Subject: VIRGIL C. SUMMER NUCLEAR STATION
DOCKET NO. 50/395
OPERATING LICENSE NO. NPF-12
STEAM GENERATOR REPLACEMENT (SGR) TECHNICAL
SPECIFICATION CHANGE REQUEST - REVISED ANALYSES
(REM 6000, TSP 930015)

Steam Line Break (SLB) Analyses

Feedwater Line Break (FWLB) Analyses

PAGE REVISIONS TO SCE&G'S LICENSING SUBMITTAL

FIGURE 3.4.4-7

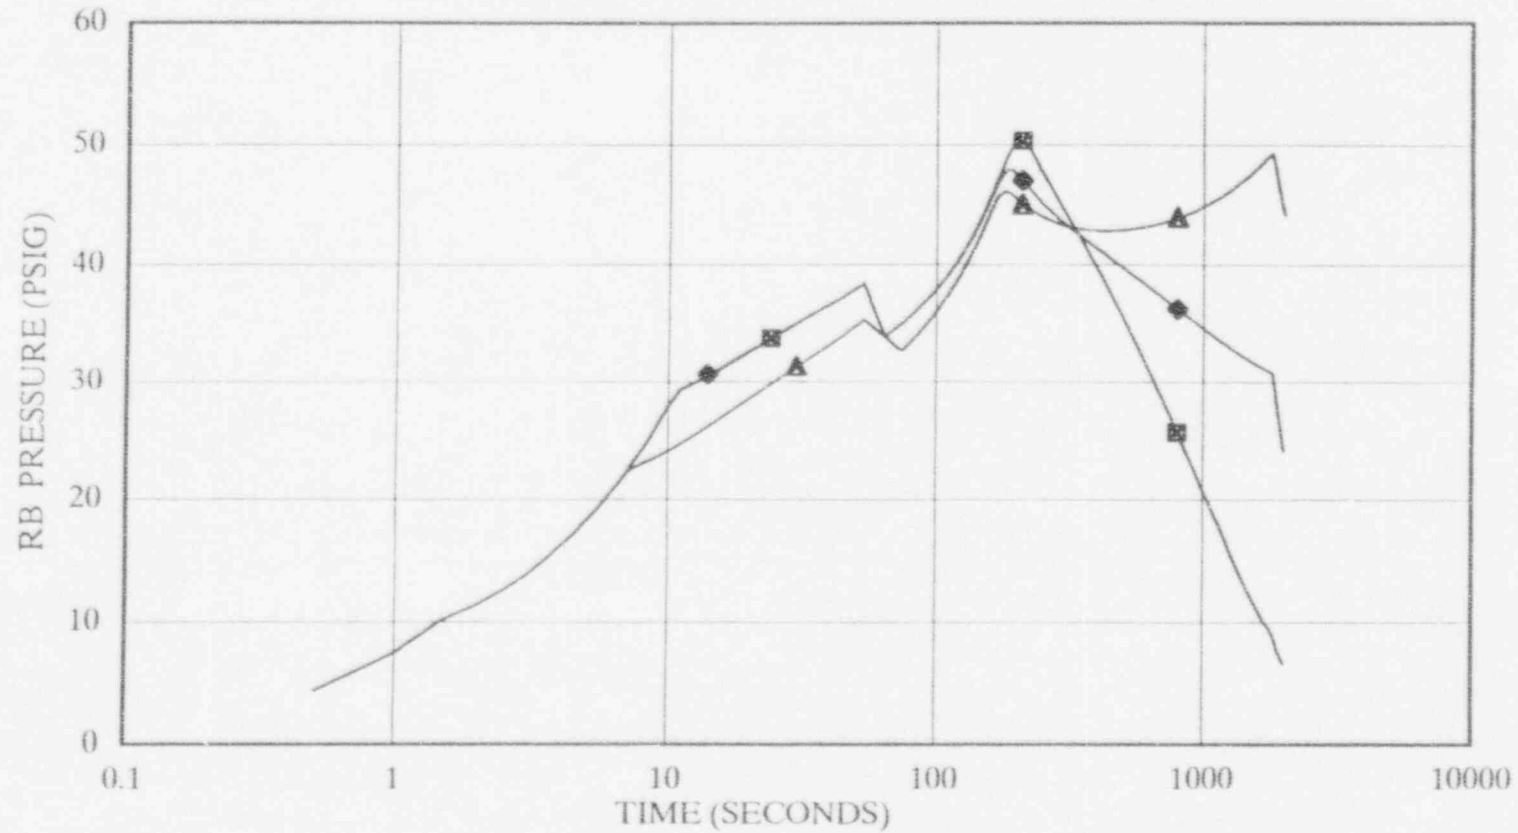
1. Analyses of the 1.4 ft² Double Ended Rupture at 102% and 25% power show that RB pressures are maximized during a SLB with a coincident failure of Electrical Channel A as shown in Figure 3.4.4-7. This limiting single failure maximizes the mass addition to the faulted SG while eliminating one train of RB cooling.

FIGURE 3.4.4-8

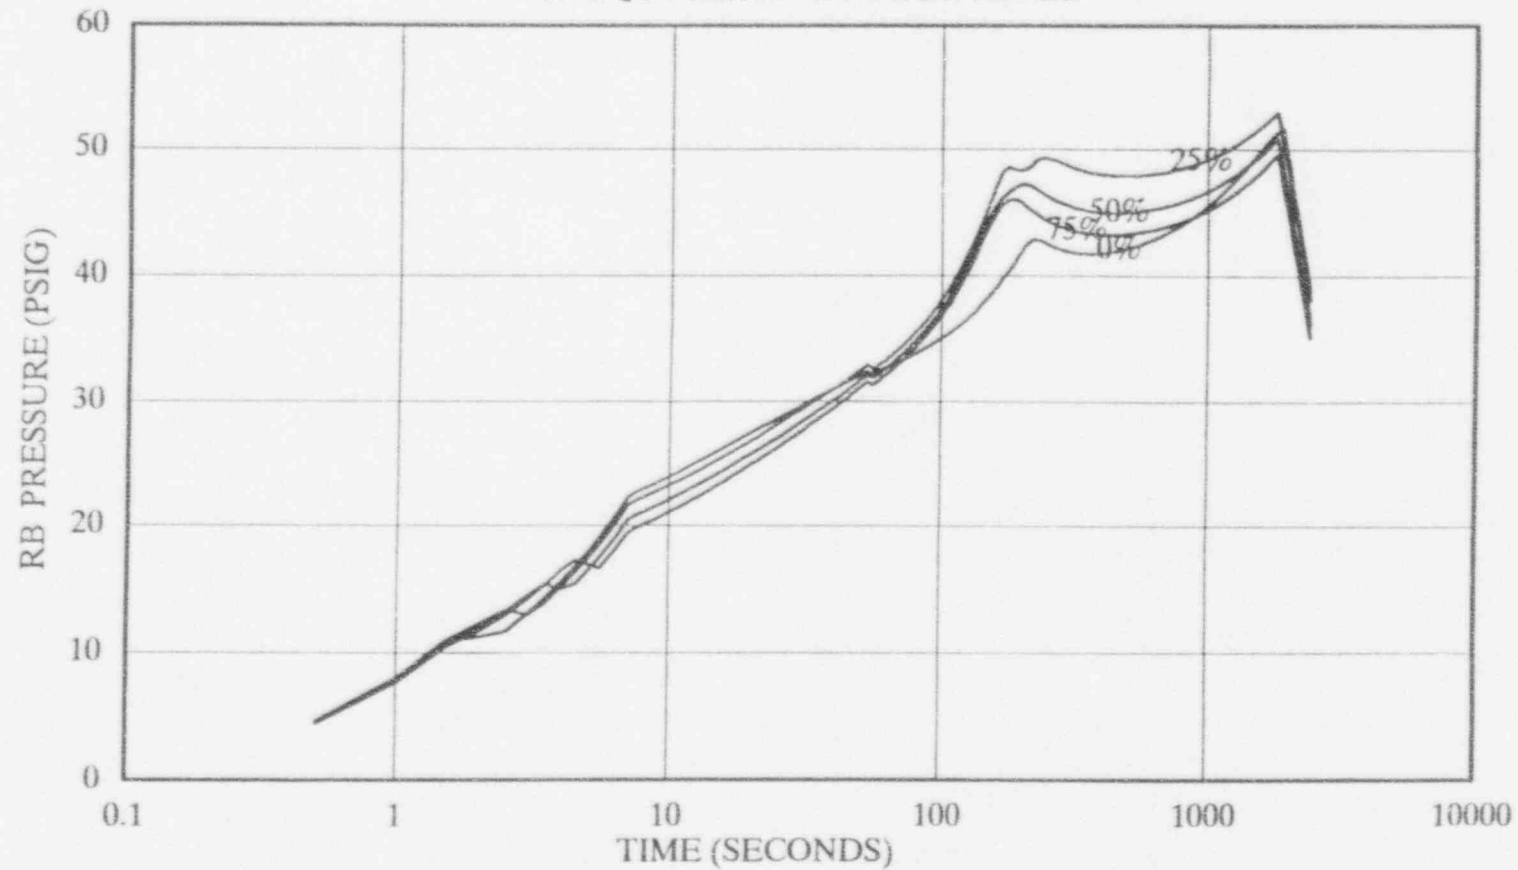
3. Maximum RB pressures occur for the large Double Ended Ruptures. The sensitivity to power level is shown in Figures 3.4.4-8 and 3.4.4-9.
4. The peak Reactor Building pressure occurs for the 1.4 ft² Double Ended Rupture at 25% power. The calculated peak pressure is 53.0 psig at 1800 seconds as shown in Figure 3.4.4-10. A 4 psig margin to the RB design pressure of 57 psig. is maintained.

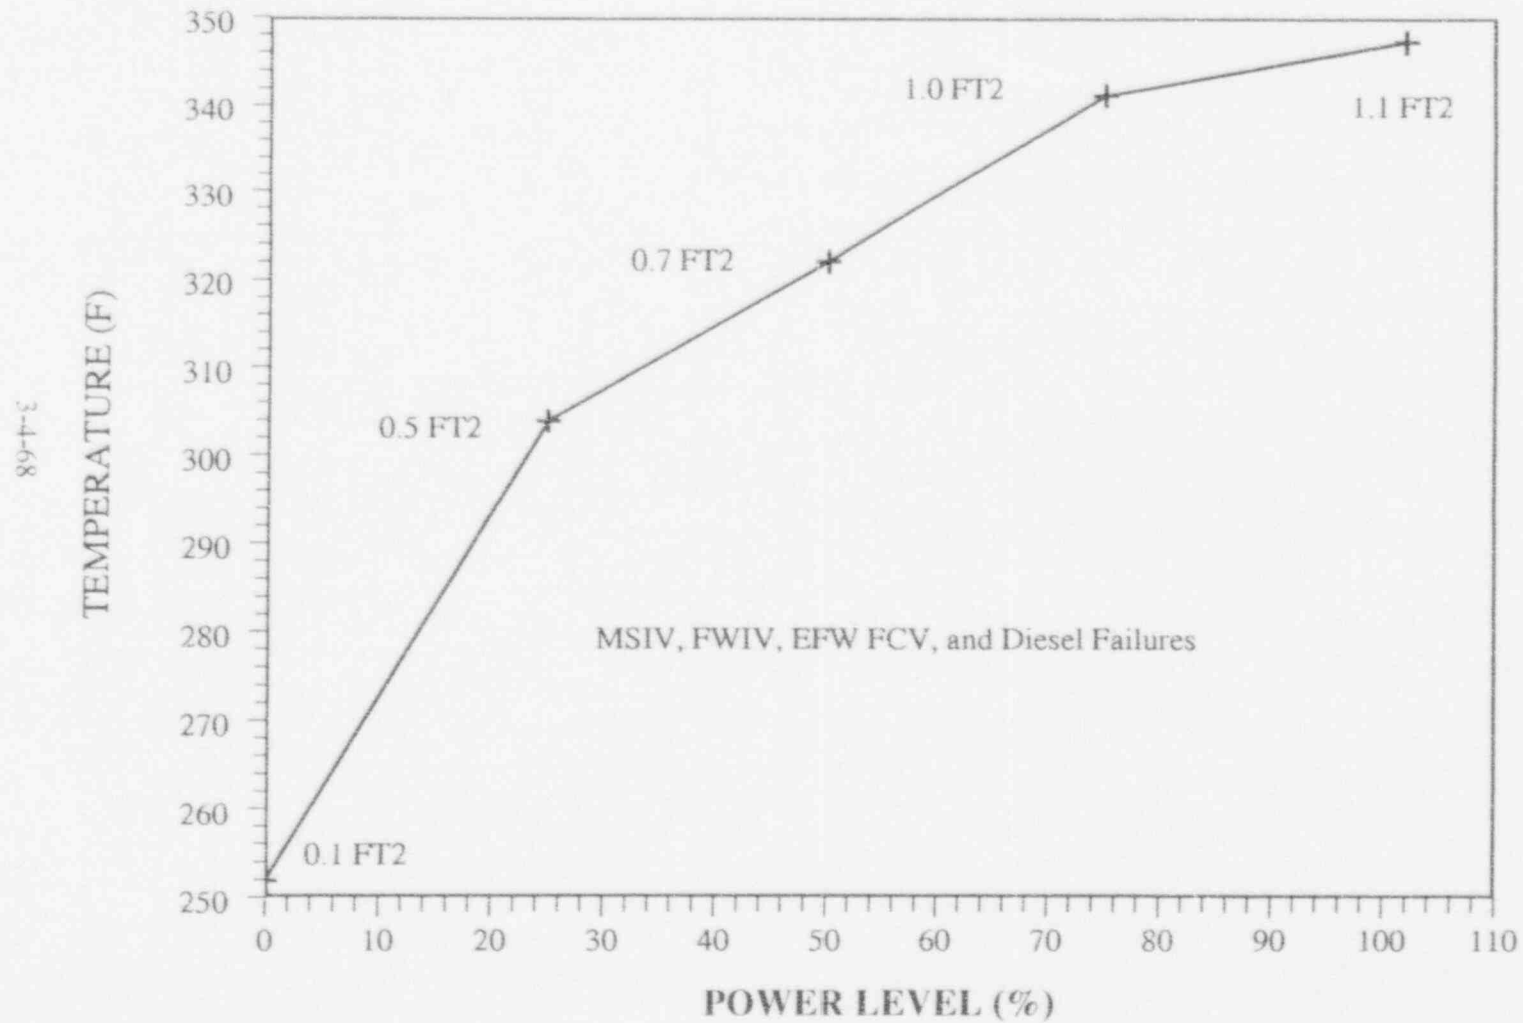
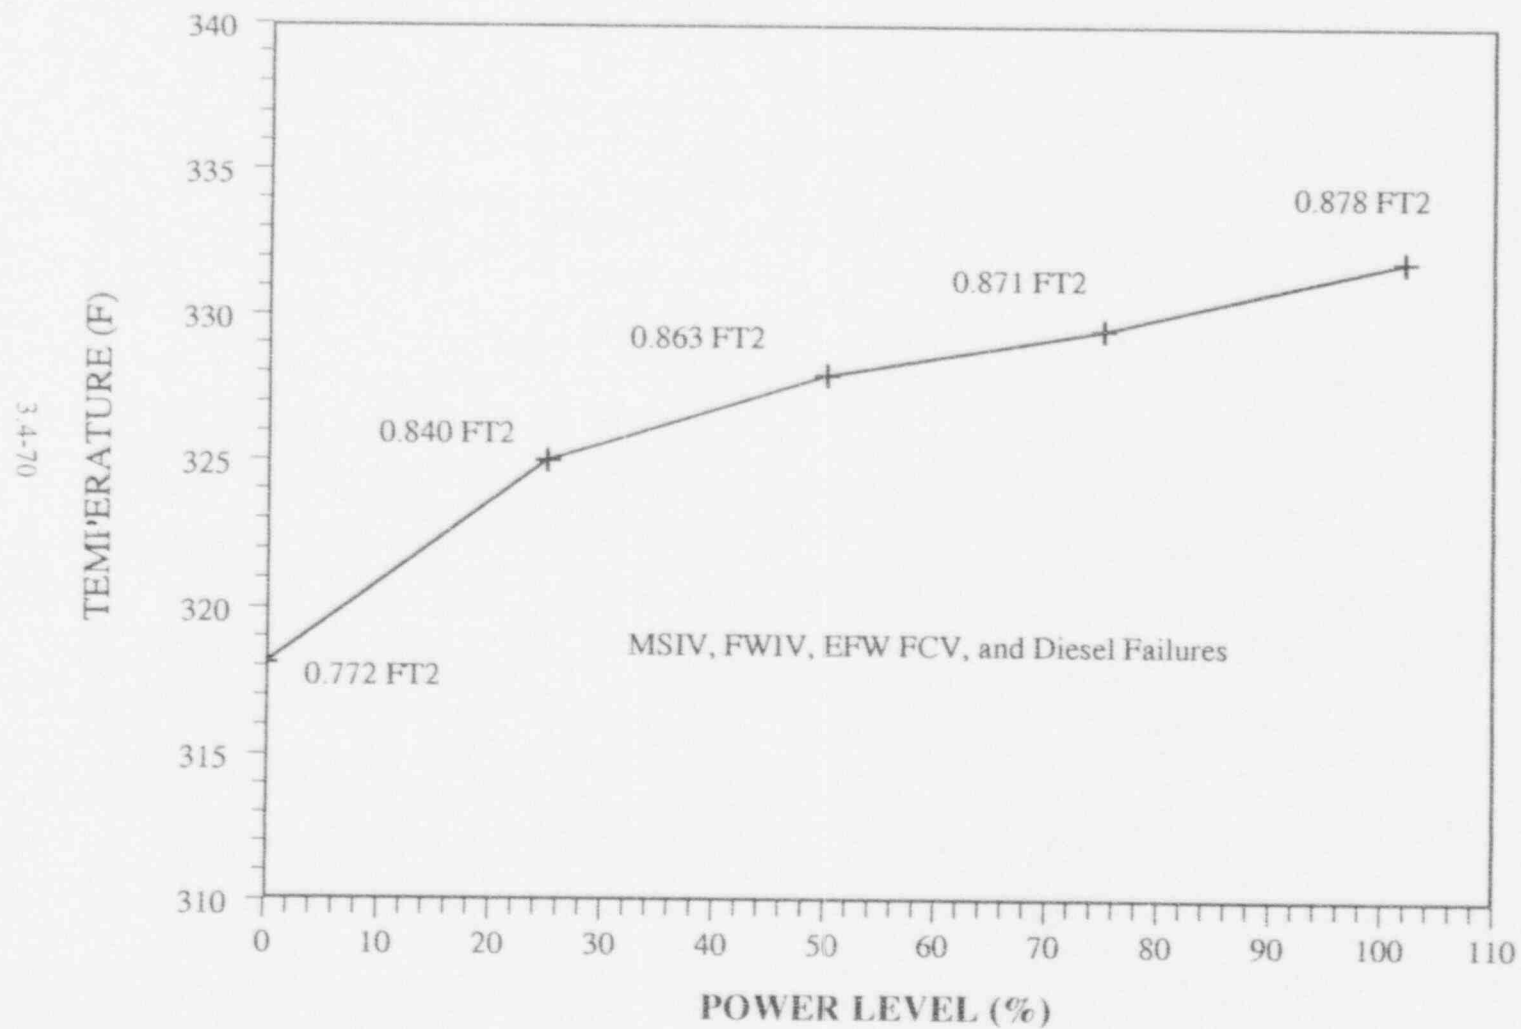
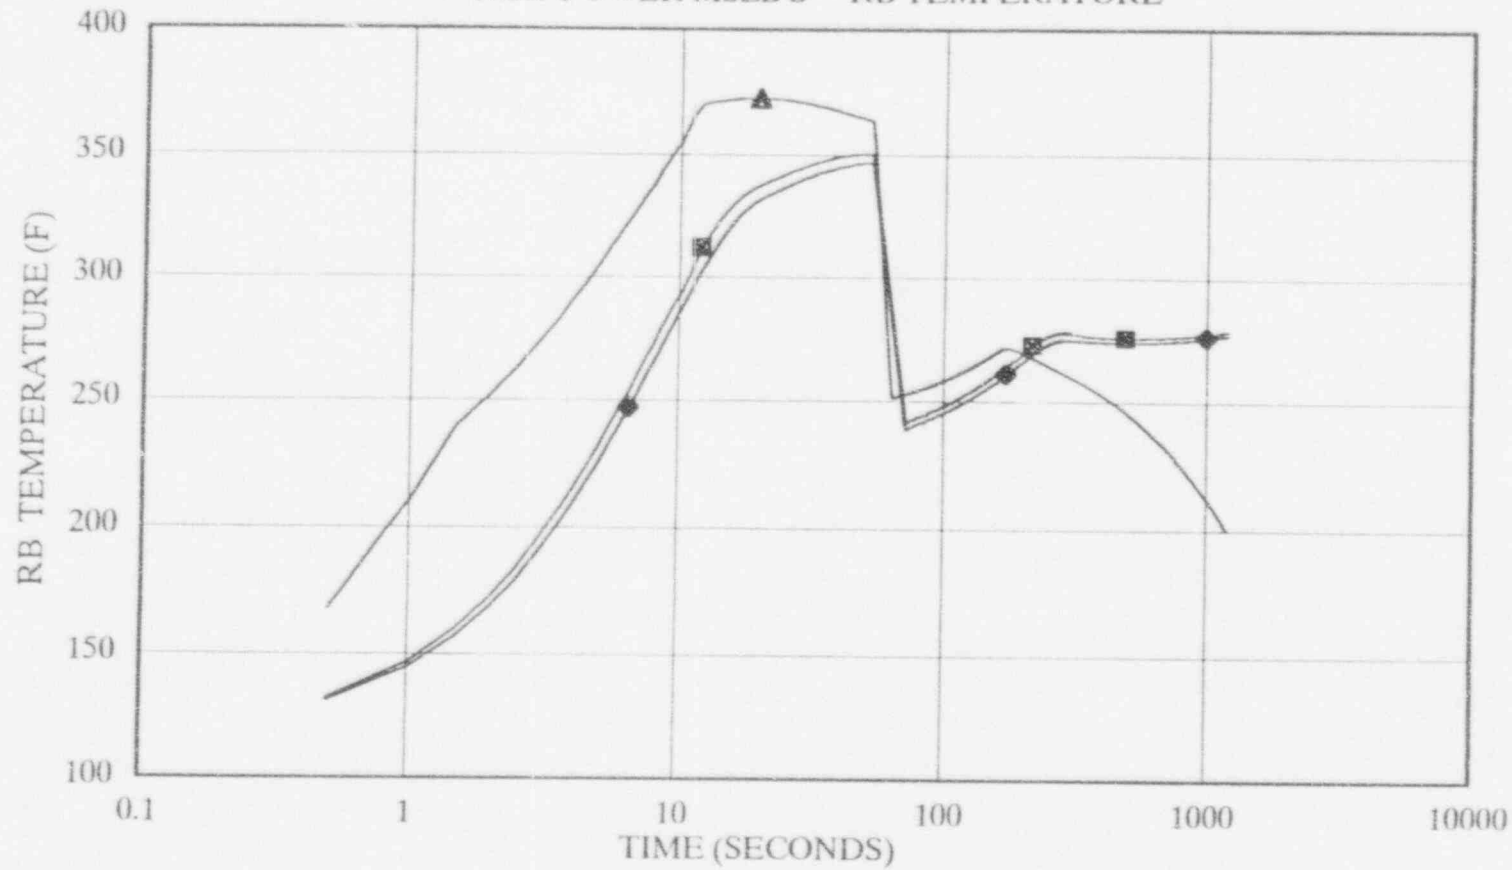
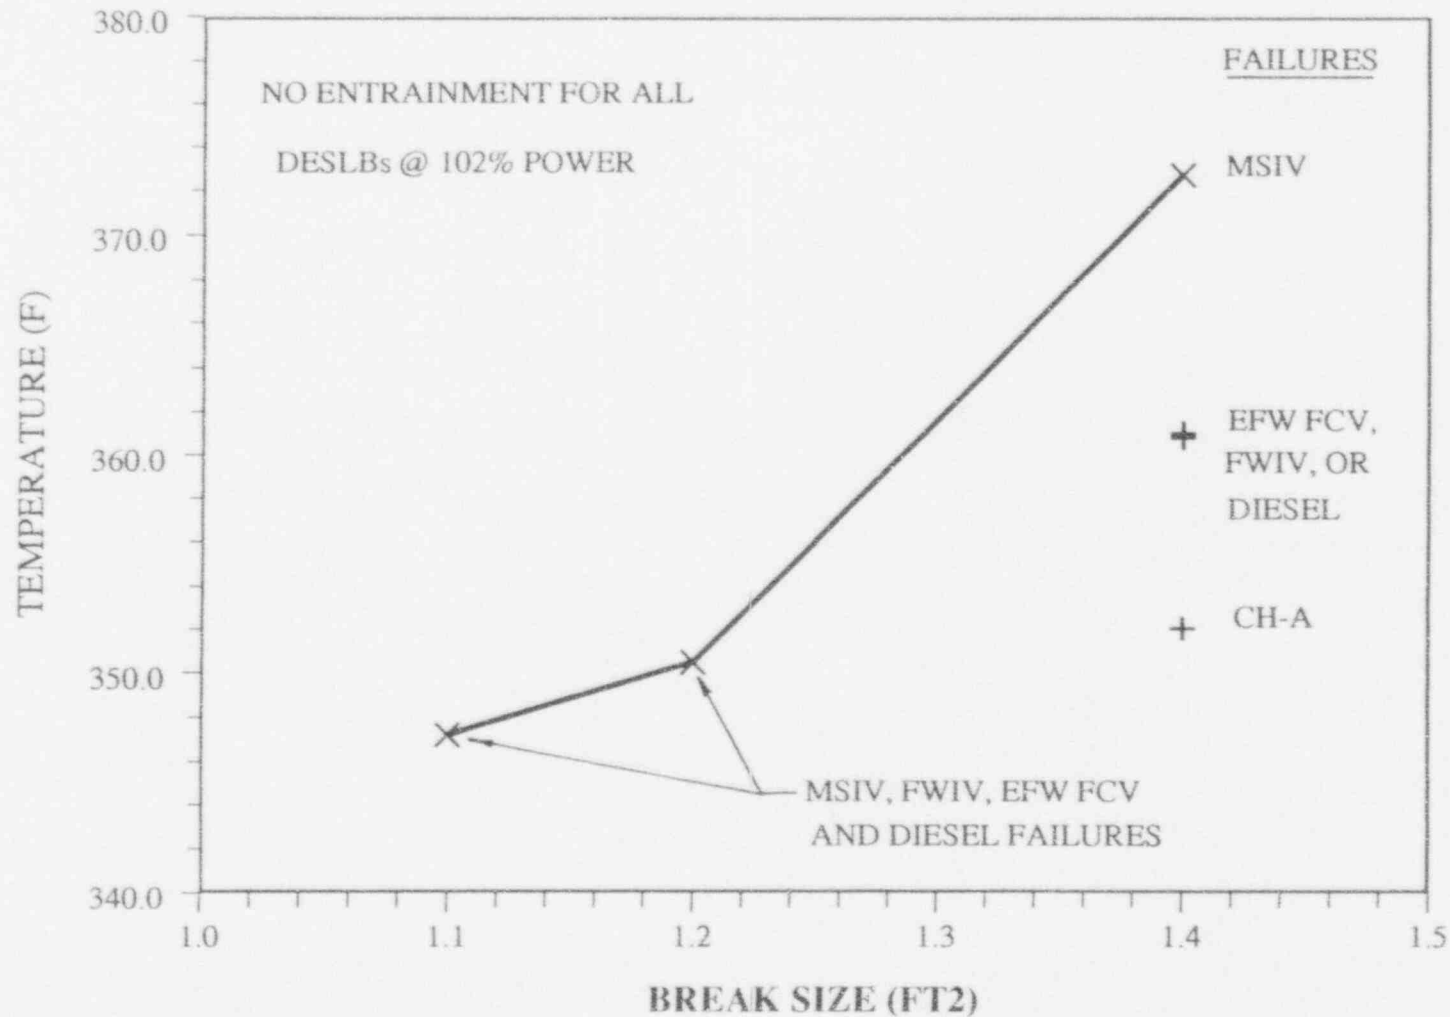
5. Superheated temperature conditions occur for the SLBs with dry blowdowns. Figures 3.4.4-11 through 3.4.4-16 show the sensitivity of peak RB temperatures for the break spectrum analyzed. Limiting conditions occur for the large Double Ended Rupture from 102% power.

FIGURE 3.4.4-17

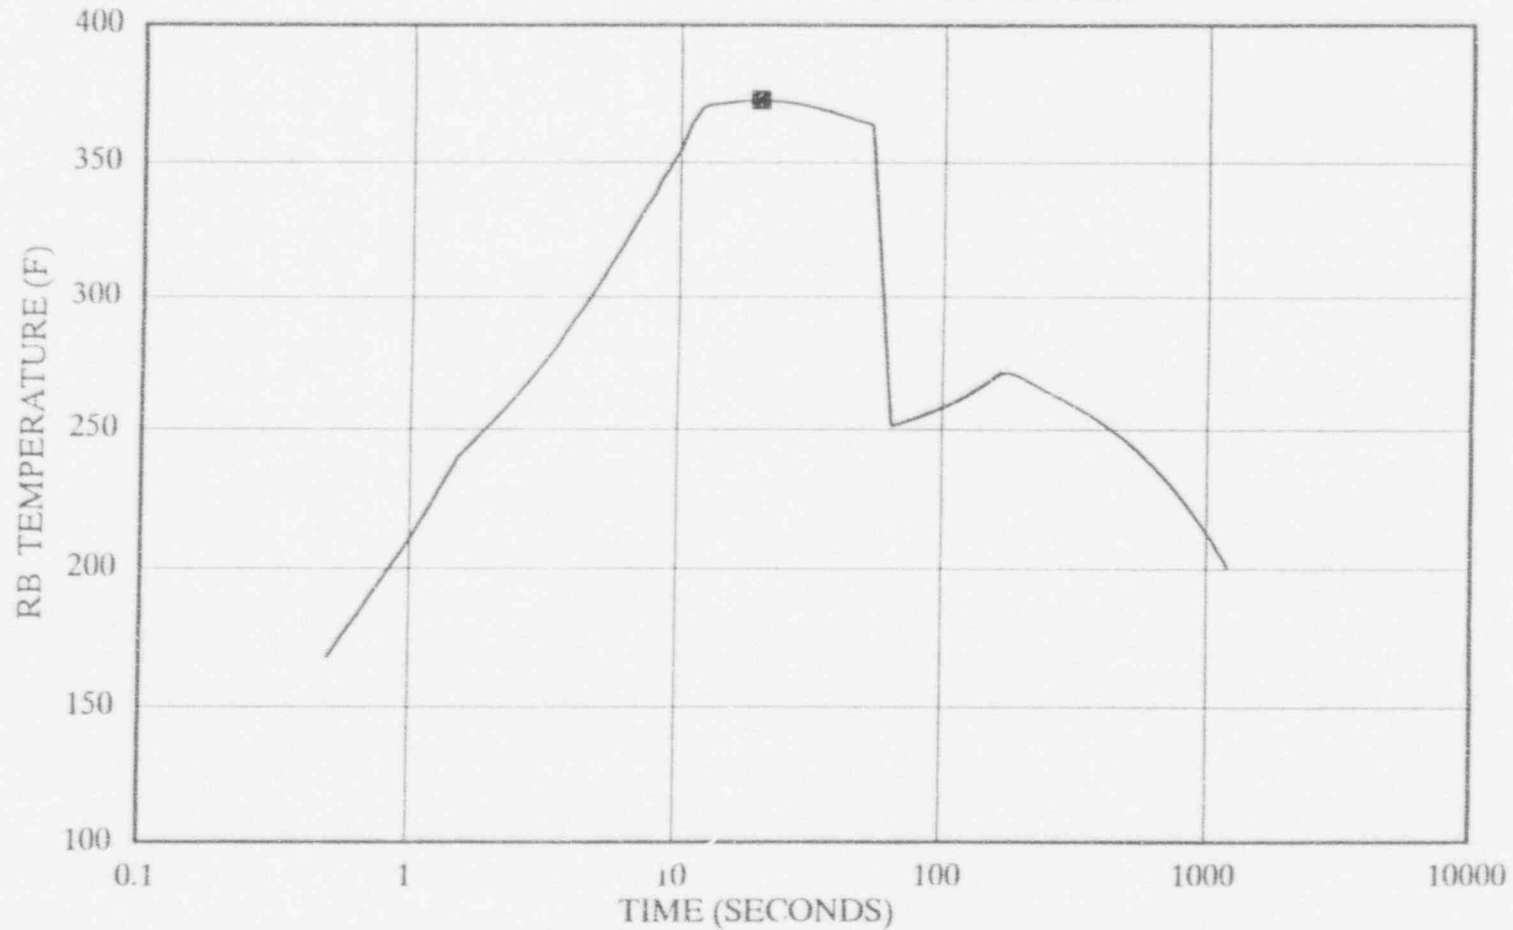
6. The peak RB temperature occurs for the 1.4 ft² Double Ended Rupture at 102% assuming a MSIV failure. The calculated peak temperature is 372.7 °F as shown in Figure 3.4.4-17. The superheated temperatures within the RB are limited in magnitude and duration via MSIV closure (stops the initial blowdown of two of the three SGs) and spray actuation. Following spray actuation, the Reactor Building remains saturated in the long term and below the RB design temperature of 283 °F.
